**Re: Hydro One Distribution Rates – Interrogatories
Ontario Energy Board File No. EB-2012-0136**

POWER WORKERS' UNION INTERROGATORIES

HYDRO ONE'S 3GIRM: CALCULATION OF THRESHOLD

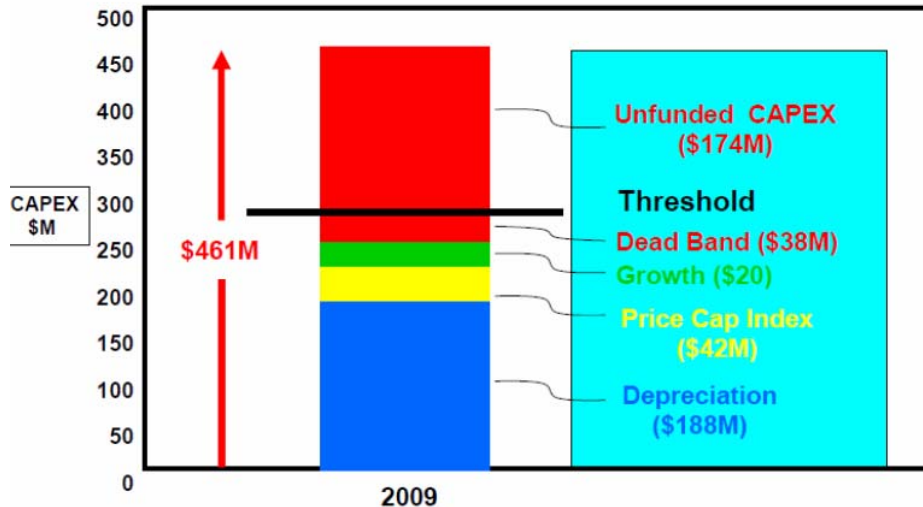
- a) Please illustrate how Hydro One's ICM application meets the OEB's ICM materiality threshold and how the incremental revenue requested will not be recovered through other means using the approach used in EB-2008-0187, Exhibit K1.15. Please provide explanation.

Figure 13 - Transformer Fleet Condition Assessment

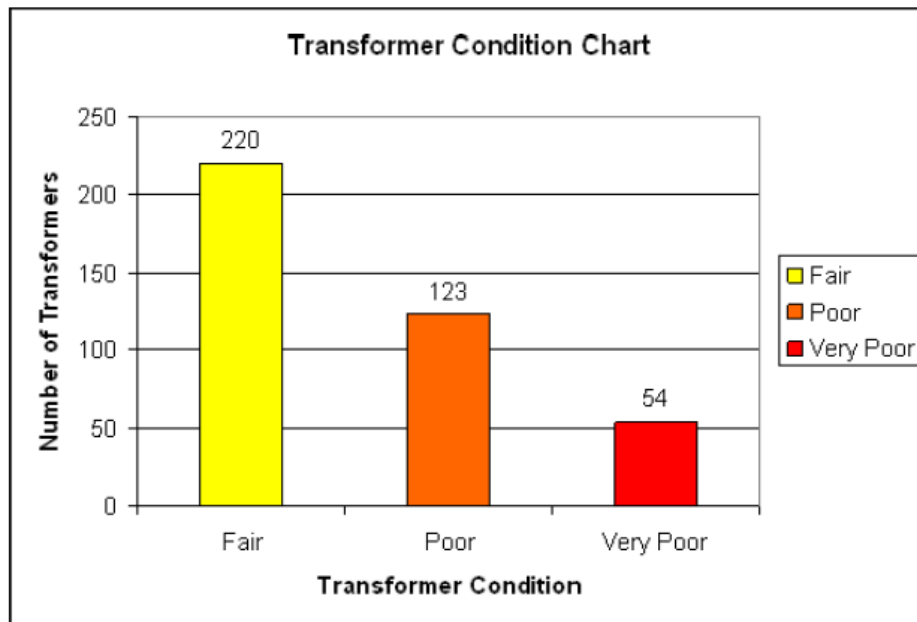
- a) What will be the impact of the proposed transformer replacement rate of 36 replacements per year on the statistics illustrated in Figure 13 (i.e. number of

transformers in Fair, Poor and Very Poor condition in each year from 2013 through 2023)? Please provide the statistics in number of transformers as well as % of total transformer numbers.

- b) Please provide the information illustrated in Figure 13, or similar information if the same information is not available, for Stations and for Wood Poles.
- c) Please provide the information requested in (a) or similar information if the same information is not available, for Stations and for Wood Poles assuming the proposed replacement rates for Stations and Wood Poles.
